**Lake County Department of Public Works**  
**Saunders Road Sanitary Sewer and Lift Station Improvements**  
**Bid #25232**  
**Project #2020.130**  
**Addendum#2 – August 22, 2025**

**Questions and Clarifications:**

## **Revisions**

**002-CK-4**

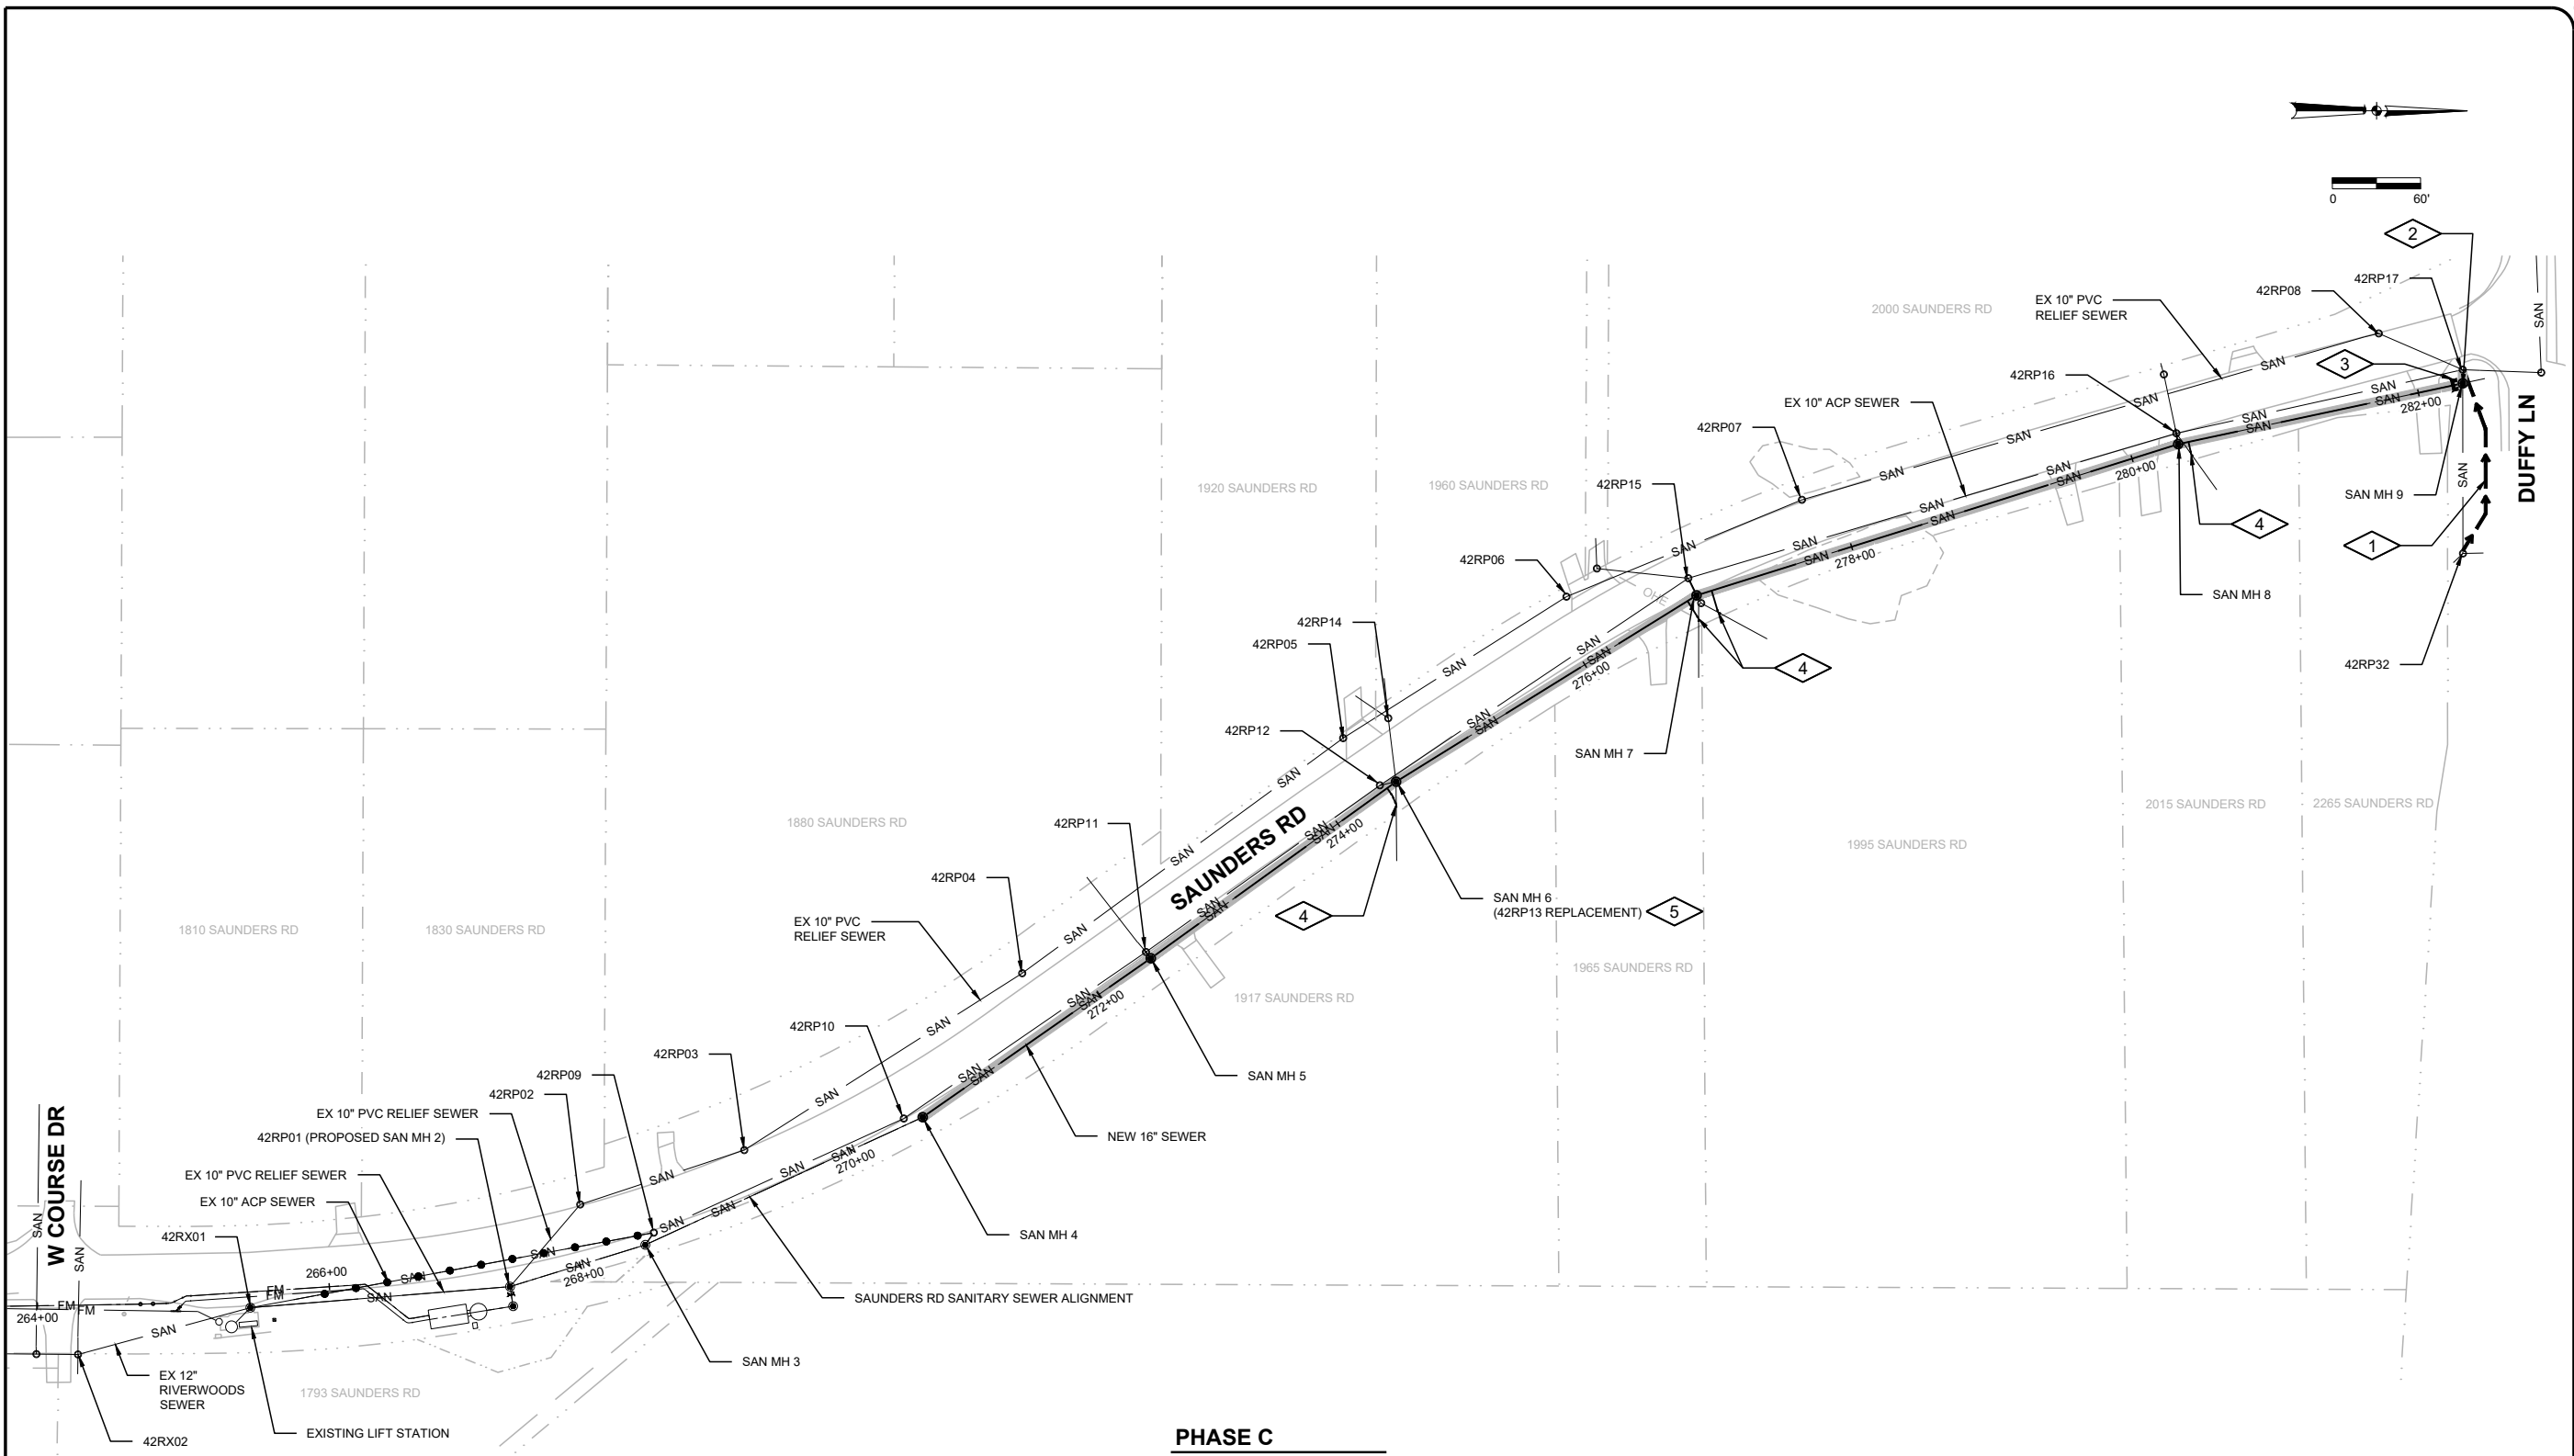
- b. Transfer sanitary sewer service lines to new 16-inch sewer as downstream portions are completed.
    - c. Provide bypass pumping from MH 42RP32 to 42RP17 for construction of SAN MH 9. Plug 10-inch diameter pipe to the east at MH42RP17 for replacement of 10-inch sewer between 42RP17 and SAN MH 9. Temporarily plug outlet from SAN MH 9 to new 16-inch diameter sewer until new sewer is ready to be placed in service.

- PROVIDE BYPASS PUMPING FROM MH 42RP32 TO 42RP17 FOR CONSTRUCTION OF SAN MH 9.
- TEMPORARILY PLUG 10-INCH DIAMETER PIPE TO THE EAST AT MH42RP17 FOR REPLACEMENT OF 10-INCH SEWER BETWEEN 42RP17 AND SAN MH 9.
- TEMPORARILY PLUG OUTLET FROM SAN MH 9 TO NEW 16-INCH SEWER UNTIL NEW SEWER IS READY TO BE PLACED IN SERVICE.
- TRANSFER EXISTING SANITARY SEWER SERVICE LINES TO NEW 16-INCH SEWER. SERVICES SHALL NOT BE TRANSFERRED UNTIL CONSTRUCTION OF NEW 16-INCH SEWER AND MANHOLES DOWNSTREAM OF SERVICE TO BE TRANSFERRED IS COMPLETE.
- PROVIDE CONTAINMENT/DISPOSAL OR OTHER MEANS OF CONVEYING SEWAGE FROM MH 42RP14 DURING REMOVAL OF MH 42RP13 AND CONSTRUCTION OF SAN MH 6.

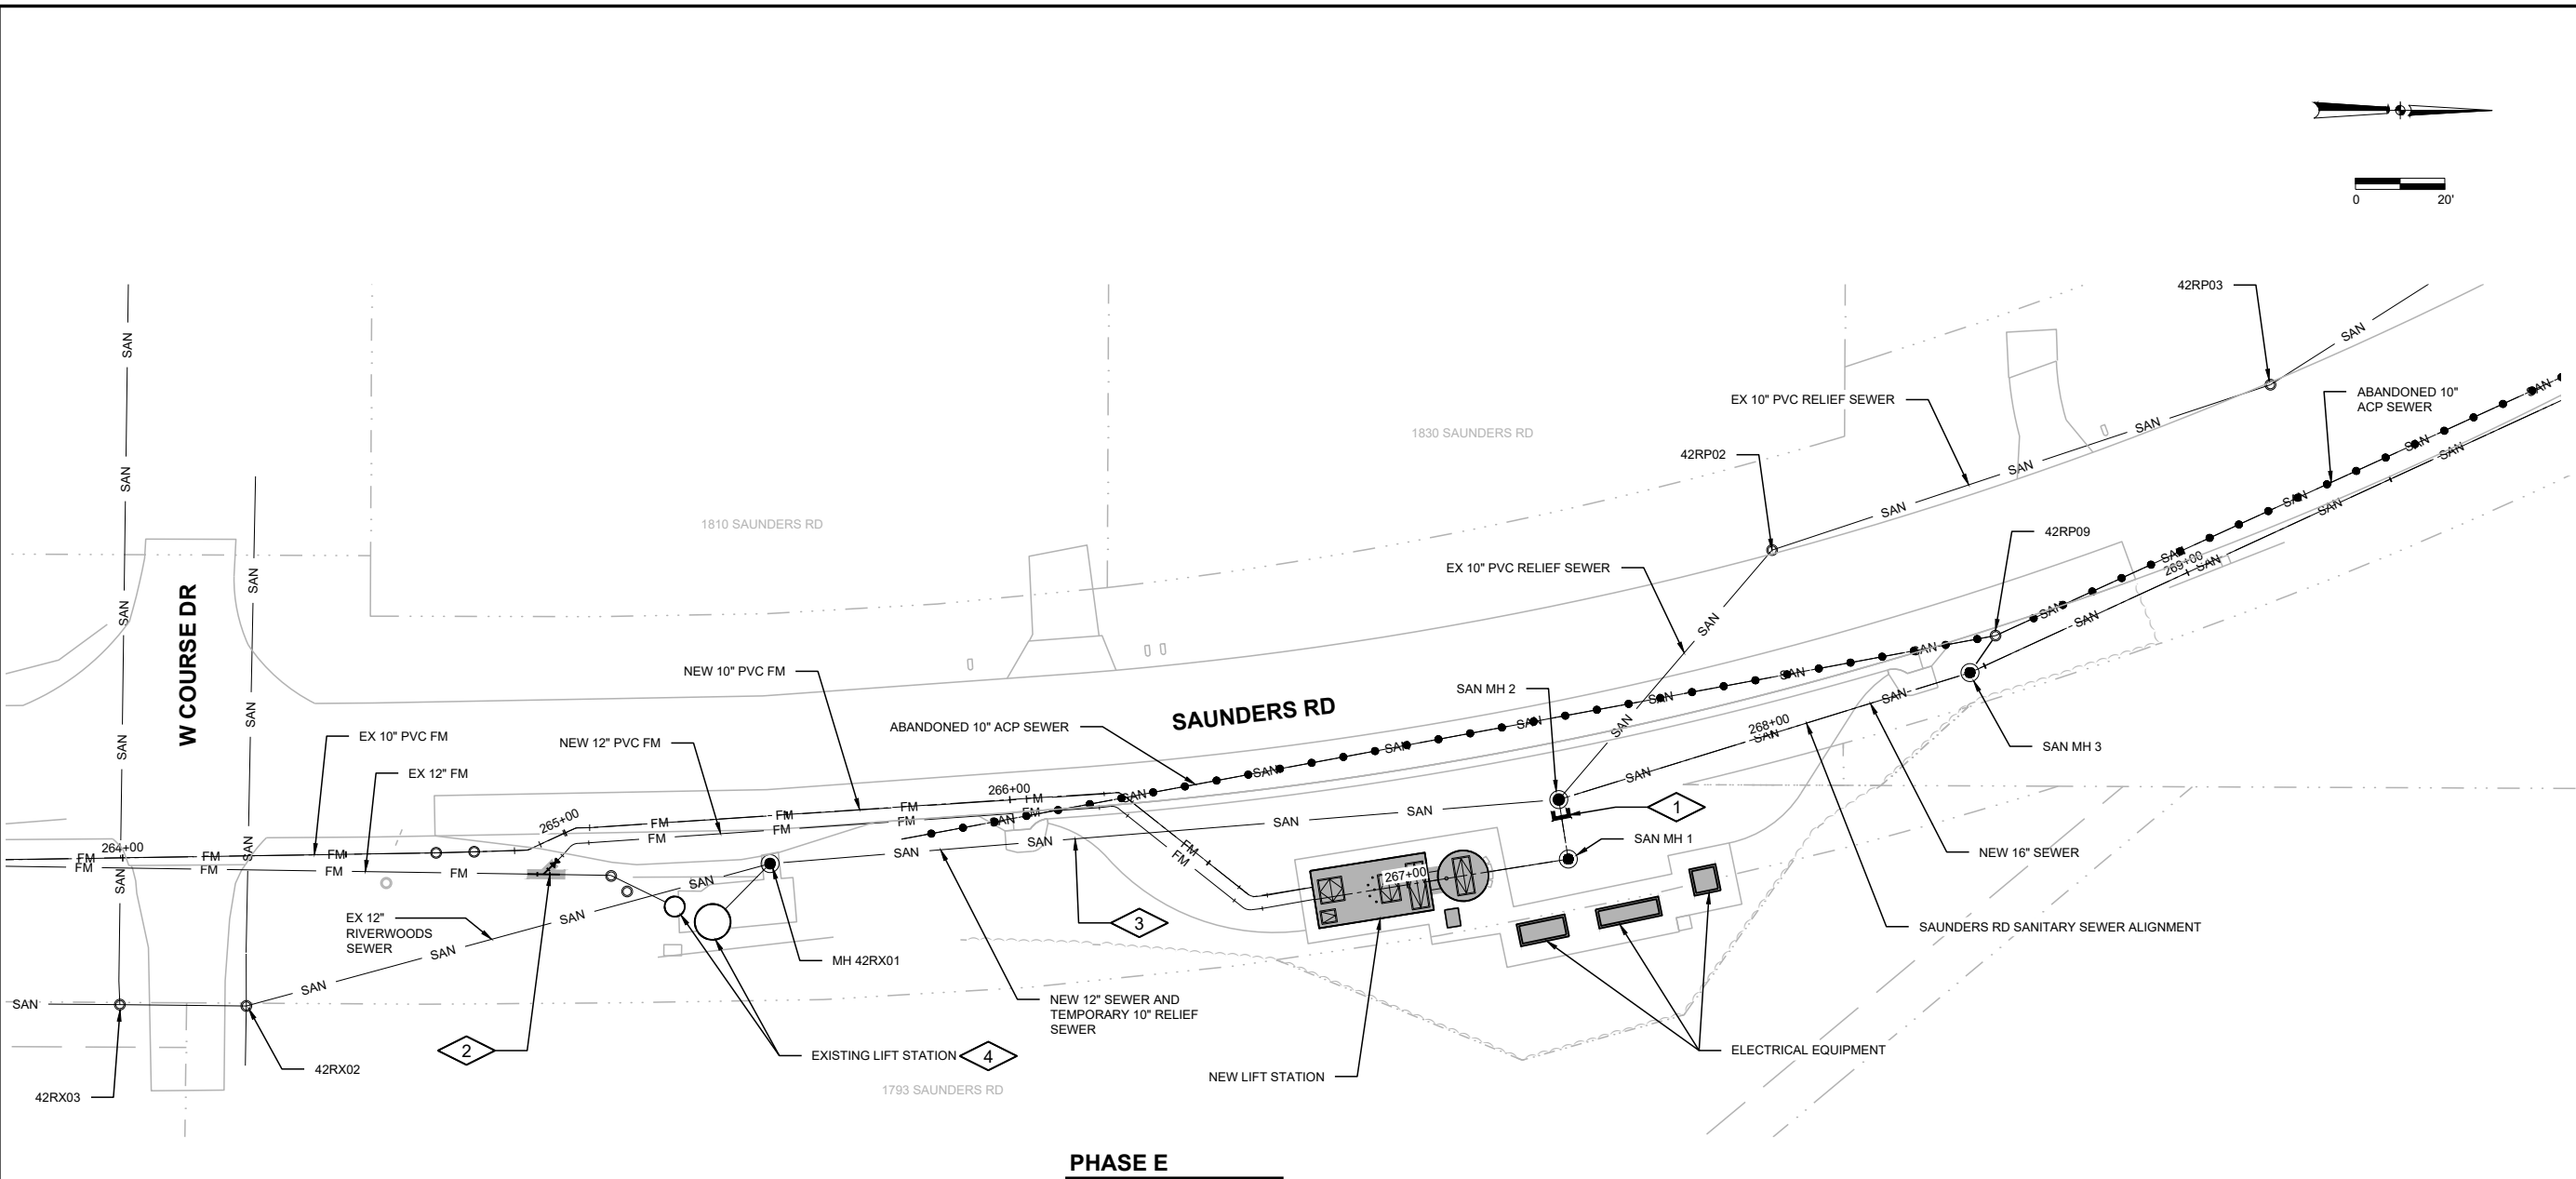
- a. Install remaining piping, equipment, and appurtenances as required to complete new lift station.
    - b. Complete lift station start-up and testing. Remove temporary plug from 24-inch outlet pipe at SAN MH 2 to route flow to new lift station.

- c. Following successful lift station start-up, remove temporary wye and valve at connection of new 12-inch diameter forcemain to existing 12-inch diameter forcemain and install permanent connection. All lift station flow to be routed through 10-inch forcemain during this time. Schedule tie-in of new 12-inch diameter forcemain during period of forecasted dry weather.

- d. Demolish existing lift station and abandon temporary 10-inch PVC relief sewer.
    - e. Complete remaining site improvements and restoration.”
3. Section 01 11 00 – Summary of Work, add the following as Part 1.03.E:

- REMOVE TEMPORARY PLUG FROM SAN MH 2 OUTLET TO SEND FLOW TO NEW LIFT STATION.
- FOLLOWING SUCCESSFUL TESTING AND START-UP OF NEW LIFT STATION, REMOVE TEMPORARY 12-INCH WYE AND VALVE. INSTALL 12-INCH 45° SWEEP BEND FOR PERMANENT CONNECTION OF NEW 12-INCH FORCEMAIN FROM NEW LIFT STATION TO EXISTING 12-INCH FORCEMAIN.
- FOLLOWING SUCCESSFUL TESTING AND START-UP OF NEW LIFT STATION, ABANDON TEMPORARY 10-INCH RELIEF SEWER. PERMANENTLY PLUG AT SAN MH 2 AND MH 42RX01.
- FOLLOWING SUCCESSFUL TESTING AND START-UP OF NEW LIFT STATION, COMPLETE REMOVALS AT EXISTING LIFT STATION. SEE 002-CR DRAWINGS.
